Proposal to amend ECE/TRANS/WP.29/GRE/2021/23

Figure 1

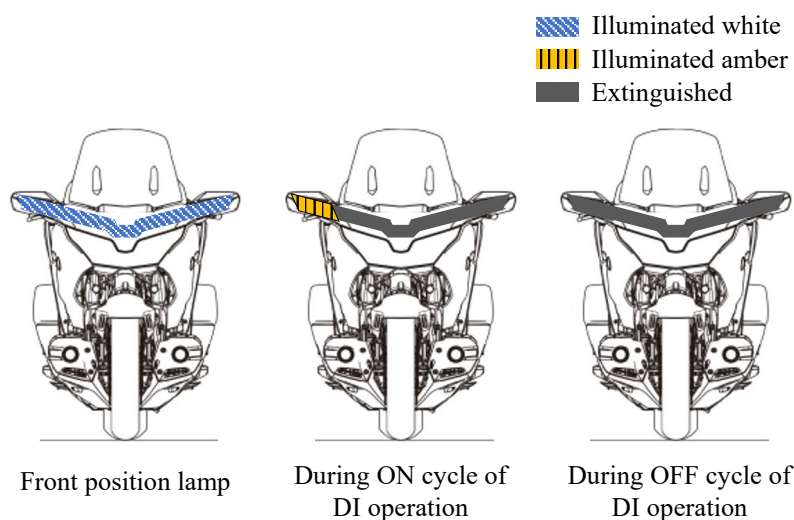
1. This proposal aims to enhance the conspicuity of motorcycles equipped with a front position lamp reciprocally incorporated with a direction indicator, by clarifying the electrical connection requirements in paragraph 6.6.7., as the current text requires the entire front position lamp to be extinguished during the operation of the direction indicator, which may reduce the motorcycle conspicuity (Figure 1).

6.6.7.1. If a front position lamp is coloured amber and reciprocally incorporated with a direction indicator, the electrical connection of the front position lamp on the relevant side of the vehicle or the reciprocally incorporated part of it shall be such that it is switched OFF during the entire time (both ON and OFF cycle) of operation of the direction indicator lamp.

Figure 2
Proposed solution

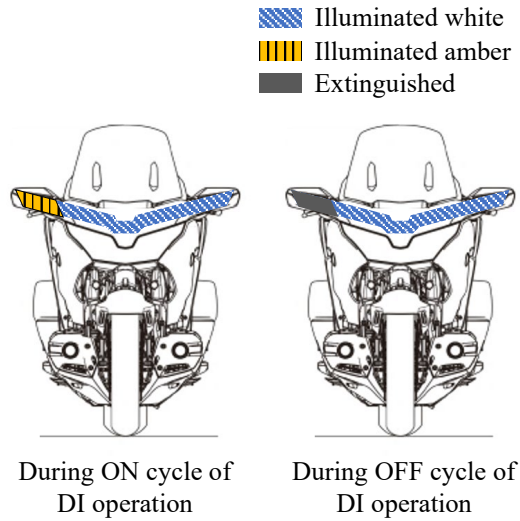
2. The amendments to working document GRE/2021/23 aim to guarantee that the motorcycle direction indicator is adequately noticed by other road users, by clarifying the intended behaviour of the reciprocally incorporated part (Figure 2) and preventing other activation possibilities (Figure 3), while streamlining the wording of paragraph 6.6.7.
